March 27, 2023

RE: 46 Old Ferry Road - Pie Hill Industrial Park  
(Tax Map Lot 1010-79-17)  
**(Response Letter to City of Methuen Staff Review Dated May 23, 2022)**

Thank you for taking time to review the above referenced site plan submission. We have been working on revising the plans to address local comments received. This letter specifically addresses staff comments provided in your email dated March 17, 2023 as well as Engineering Division comments dated March 14, 2023, and The Engineering Corp. comments dated March 14, 2023. The original comments from the email and letters are shown below and our responses are shown in **red**.

## Hydrant Flow Test

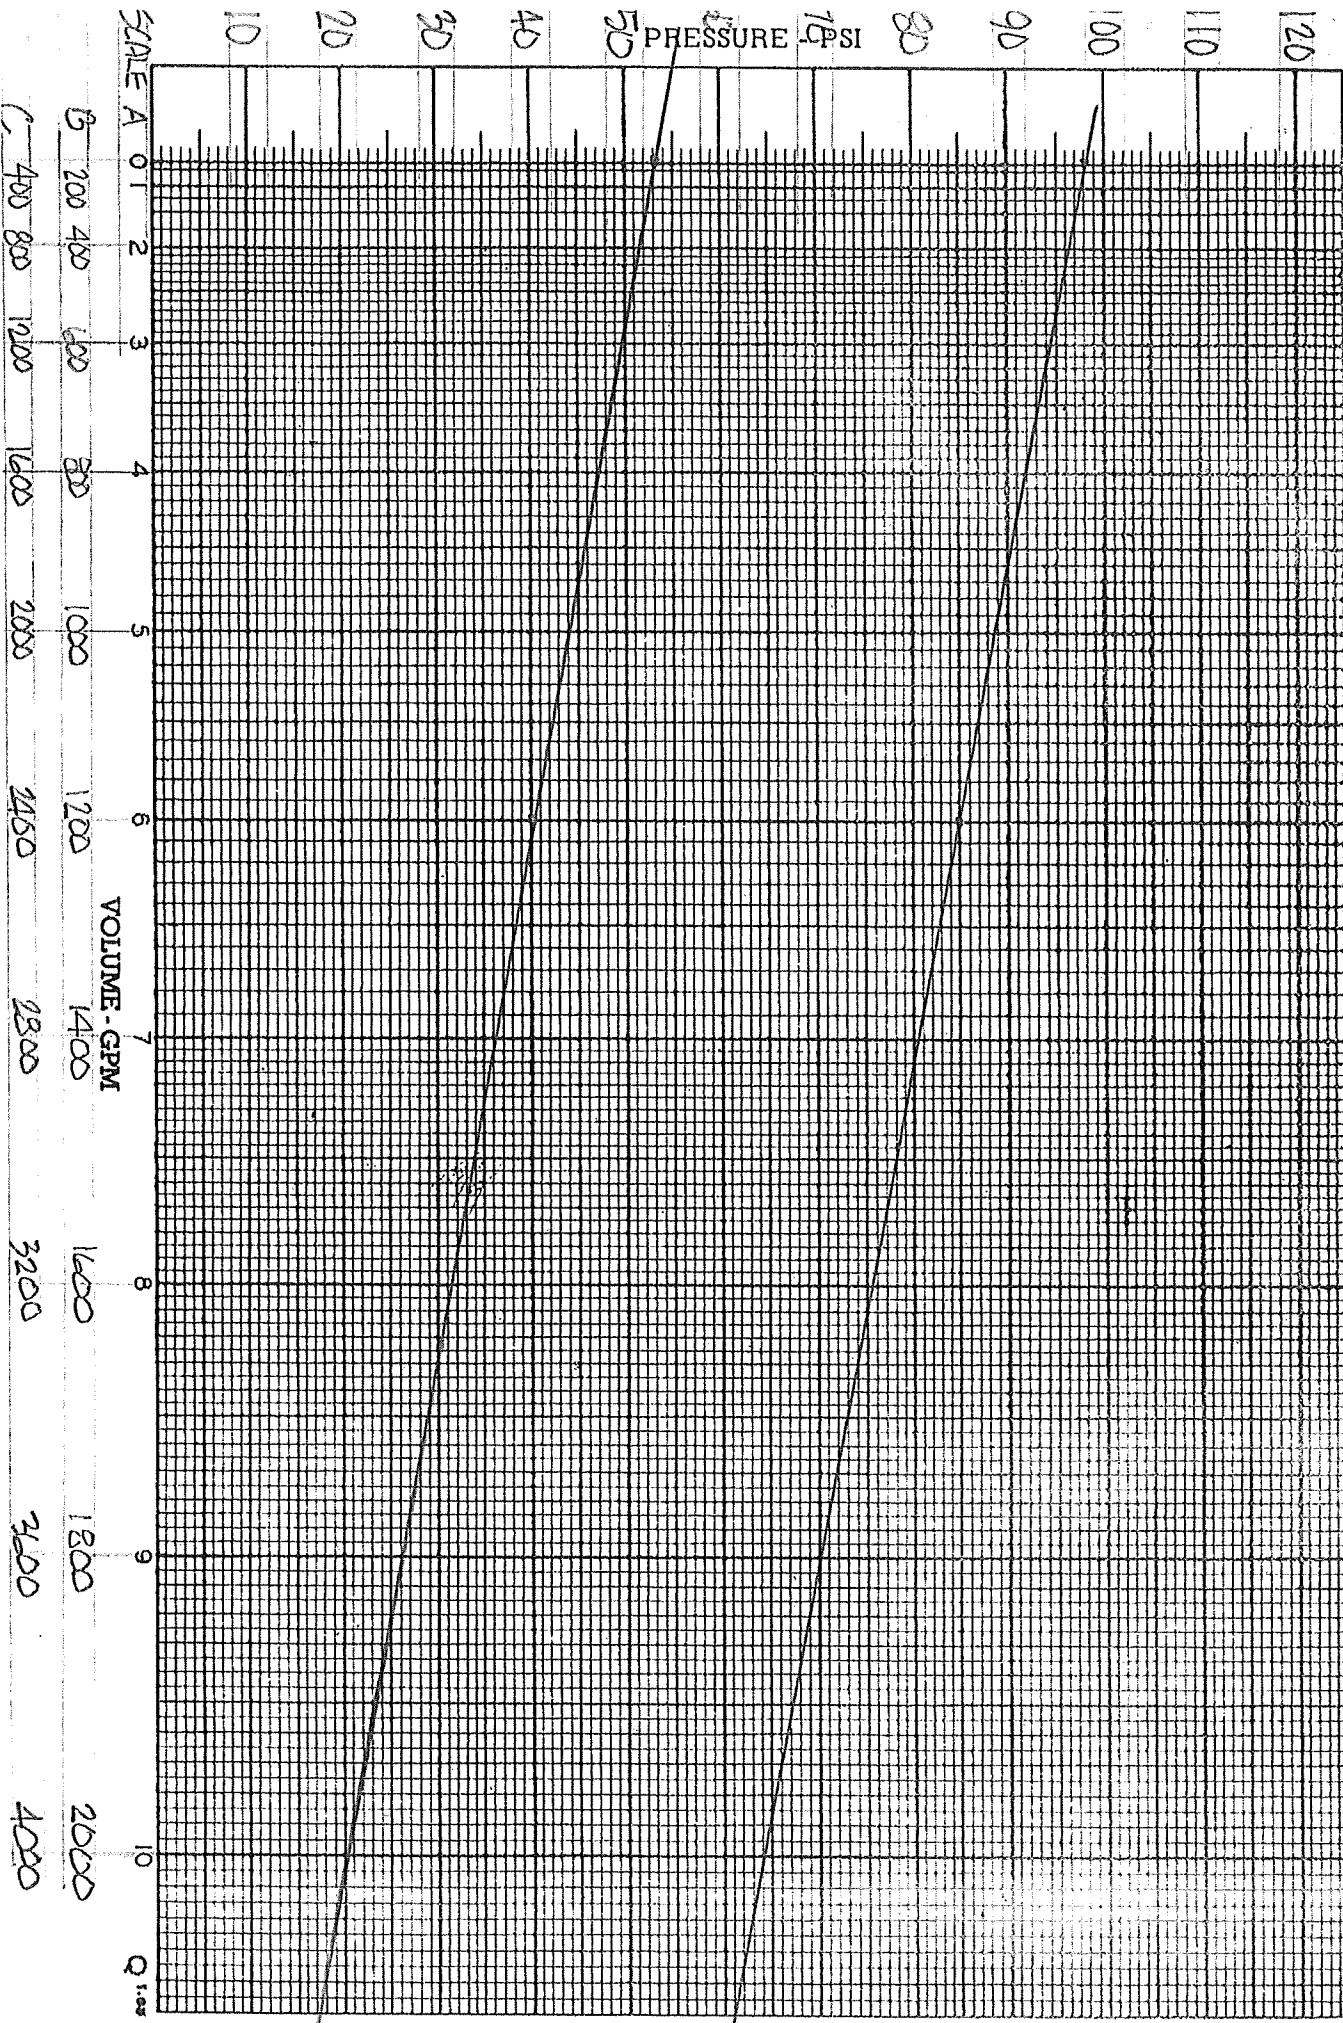
4. The previously submitted water supply analysis must be revised and resubmitted to account for the proposed change in building elevations.

*The previously submitted water supply analysis used an estimated finished floor elevation of 256.0 which exceeds the current proposed finished floor of 250.0. The expected water flow still be able to meet the 40 psi with 1202 GPM per the analysis.*
